TECHNICAL REPORT

AMENDMENT 2

**Performance of high-voltage direct current (HVDC) systems with line-commutated converters –
Part 2: Faults and switching**

Figure 10 – Example of d.c. protection zones for series-connected converter units

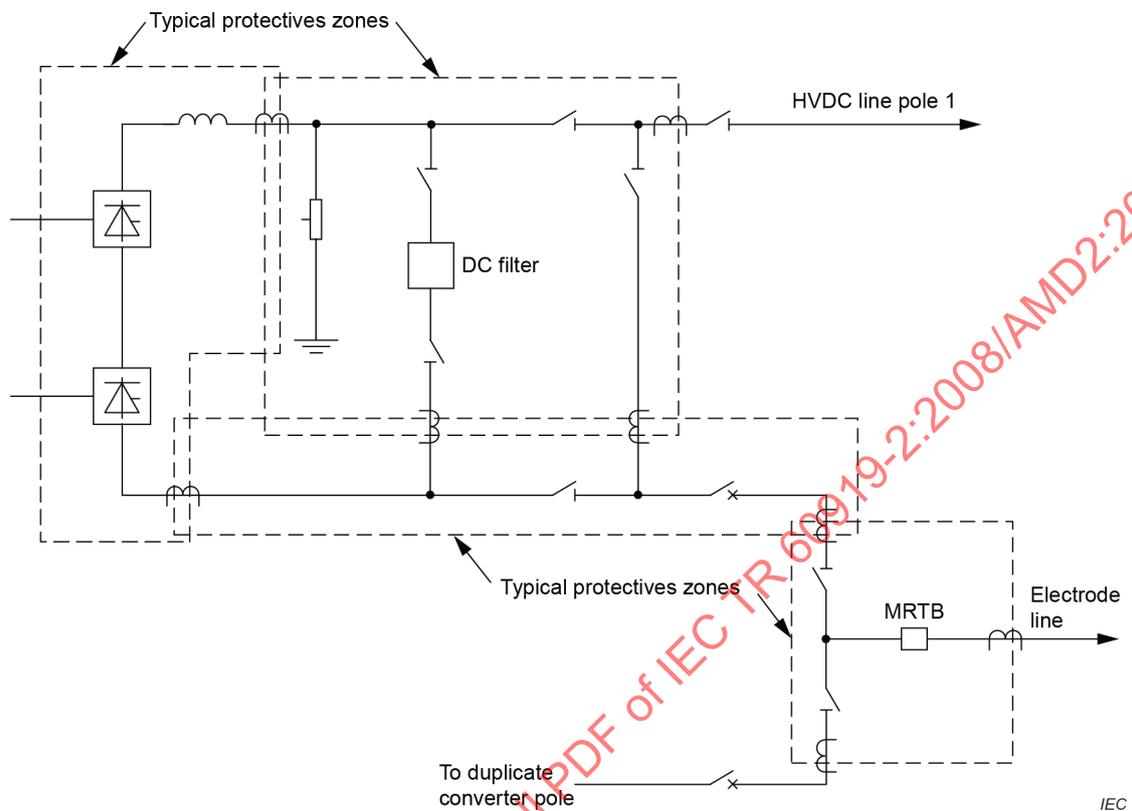
The adjacent zones should be overlapped in actual system in order to eliminate blind spots of protective scheme.

Replace the existing Figure 10 by the following new figure

Figure 11 – Example of d.c. protection zones for parallel-connected converter pole

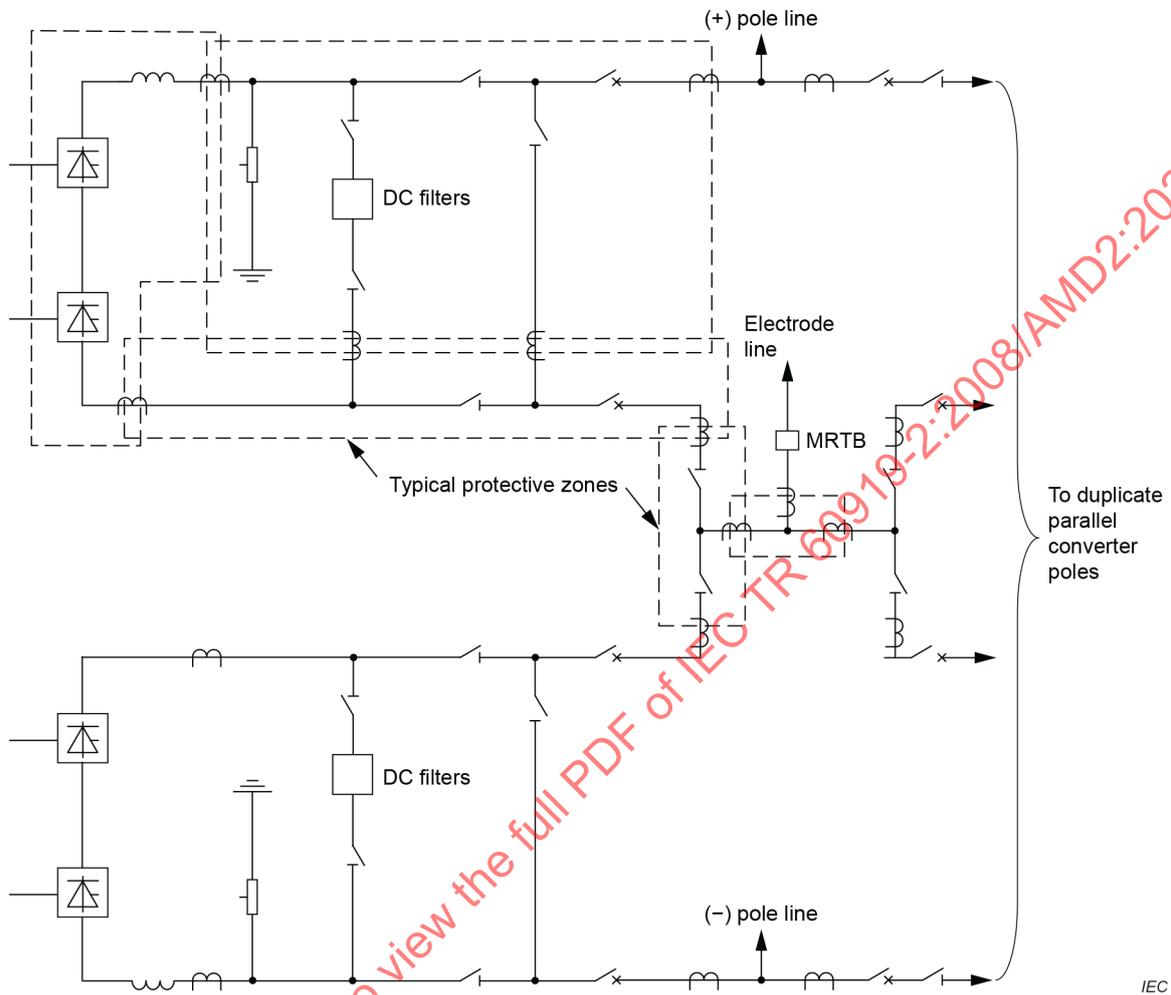
Replace the existing Figure 11 by the following new figure:
